## MEMORANDUM

**Date:** 1/13/2017  
**To:** Planning Commission  
**From:** Kaitie Meador, Associate Planner  
**Re:** 755 & 763 Cambridge Avenue – Determination of Substantial Conformance

### **Proposed Revisions**

SHEET TITLE:  
**APPROVED  
 ELEVATIONS**

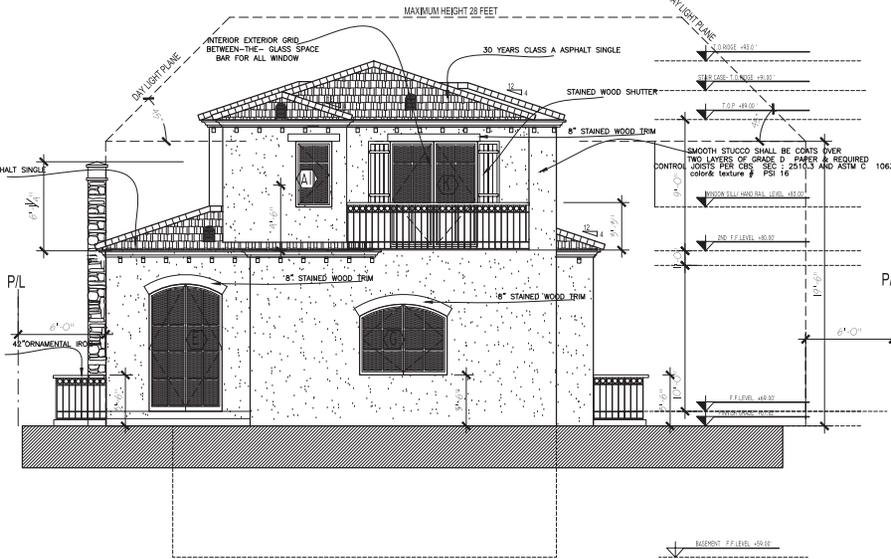
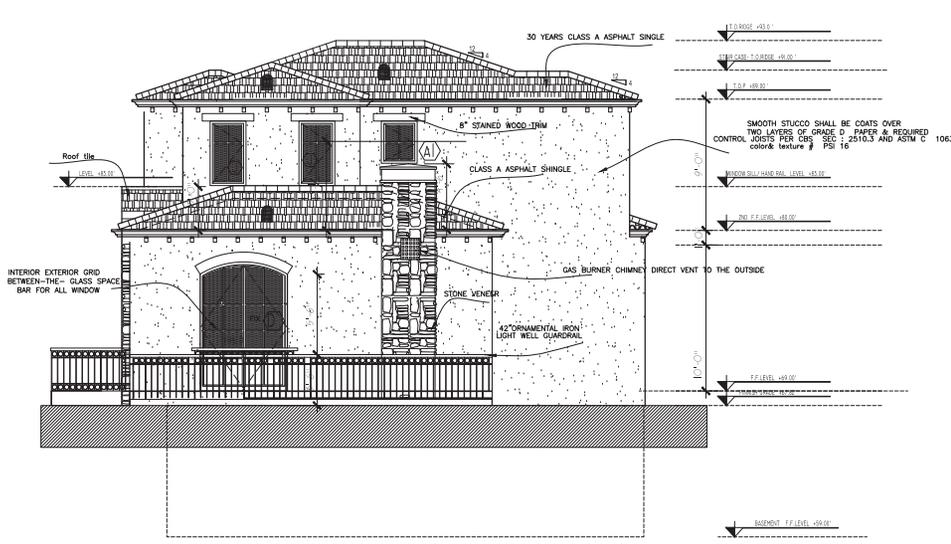
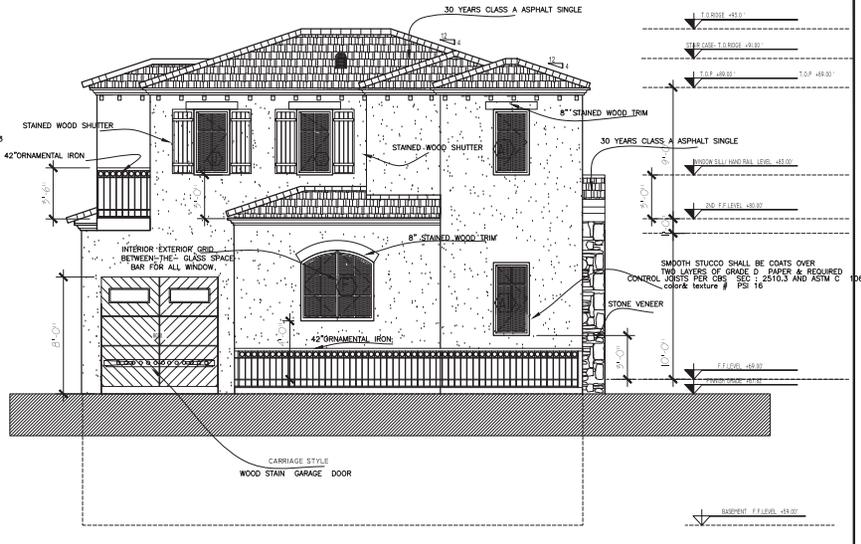
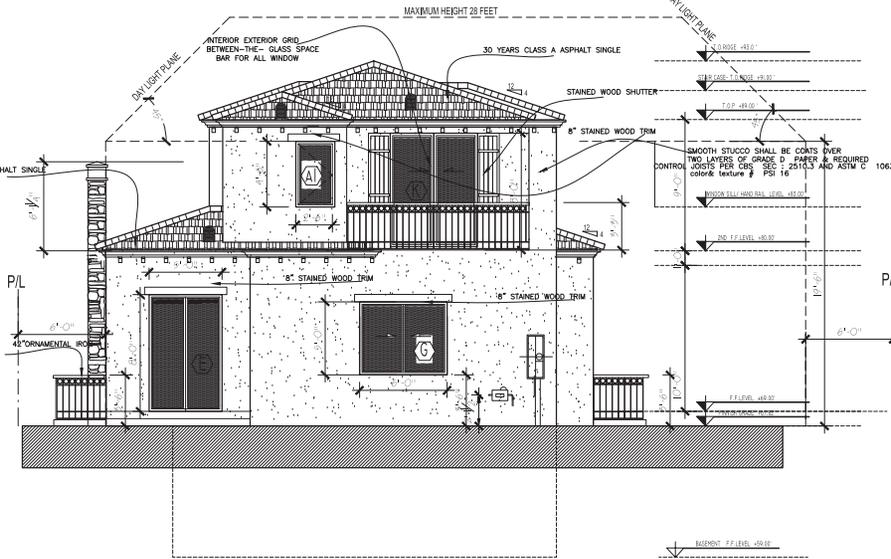
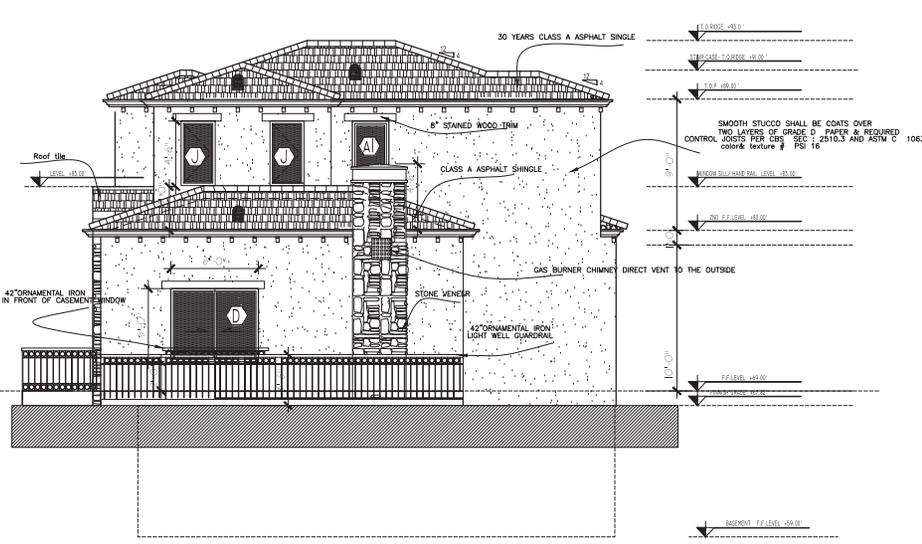
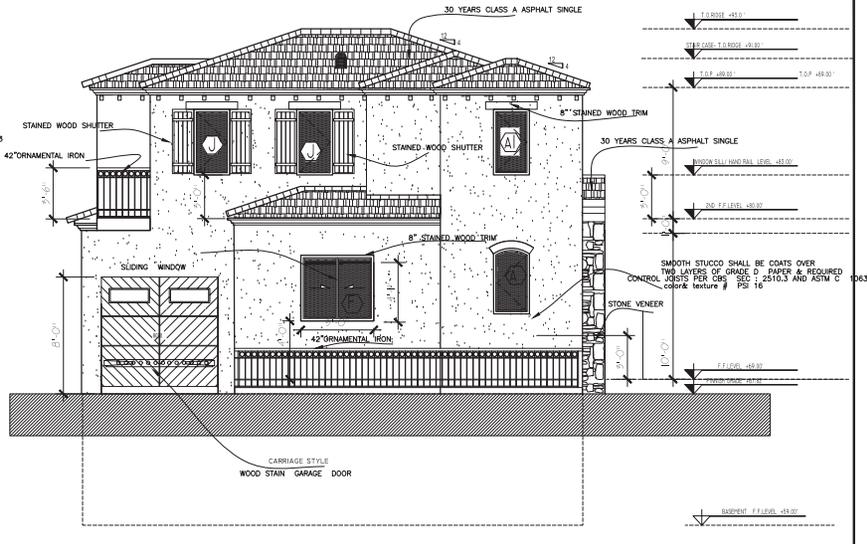
The applicant is requesting to modify the approved elevations (Attachment A) by comprehensively changing the type of windows/doors on both residences on the property. The proposed windows/doors would change from simulated divided lite with interior/exterior grids to windows/doors with no grids. Many of the proposed windows/doors would feature slight size changes including changes in shape. Several arched windows/doors would be changed to rectangle frames. The proposal also includes the removal of a ground-level terrace and ornamental iron railing on the front elevations. The applicant states that the proposed changes would accommodate standard size windows/doors and create better proportions on the elevations. The applicant has submitted a project description letter and revised elevations, included

Unfortunately, we have encountered a glitch in regards to window sizes, and we were advised by a few well-known companies such as Anderson, Pella, Millgard and Hurd to revisit and change our window sizes for better harmony and aesthetic results.

Apparently our window and door sizes, which were drawn by our architect, were nowhere near standard sizes and given the house sizes the windows and doors would give us a non-proportional outcome.

So we spent some time to view the newly built homes near our project and on Cambridge Ave. We have decided to revise our windows and doors in order to have a better harmonious look and be compatible with fresh new houses in our neighborhood. The below table demonstrates the new proposed changes.

Window Type	Approved Plans	Proposed Plans
A	Rectangle with Grid	Rectangle No Grid
A1	Arched w/grid,	Arched without/Grid, 6 inches shorter
I	Casement w/grid	Sliding without/grid
H	No changes	
G	Arched Casement w/grid,	Rectangle sliding No Grid, 2 inches taller
F	Arched Casement w/grid,	Rectangle sliding No Grid, 4 inches shorter
D	Arched Casement w/grid	Rectangle sliding No Grid, 46 inches shorter
C	Arched fixed w/grid	Arched Fixed without/grid, 22 inches shorter
B	Arched Casement w/grid	Arched Fixed without/grid, 22 inches shorter
E	Arched inswing w/grid	Rectangle inswing No Grid, 10 inches shorter
K	inswing w/grid	sliding No Grid, 6 inches taller
L	inswing w/grid	sliding No Grid, 6 inches taller
J	with Grid	Without Grid
M	Inswing w/grid	Fixed, without Grid, 30 inches shorter
W1	Arched top	Arched top, 6 inches wider

Staff has determined that the changes to the project plans are in substantial conformance with the Planning Commission's previous use permit recommendation based on the following:

- The modifications to the windows would not affect the overall integrity of the architectural design, and would not result in greater privacy impacts to neighbors, since the windows would all have comparable sizes and sill heights.
- The proposed windows without girds are compatible with the approved Tuscan southwestern architectural style, and the windows would be consistent throughout the residences.
- Architectural interest would be maintained by the stained wood headers, window shutters, and solid wood stained front door.
- The project modification meets all development regulations in the R-2 zoning district with respect to setbacks, height, daylight plane, floor area limit, and building coverage.
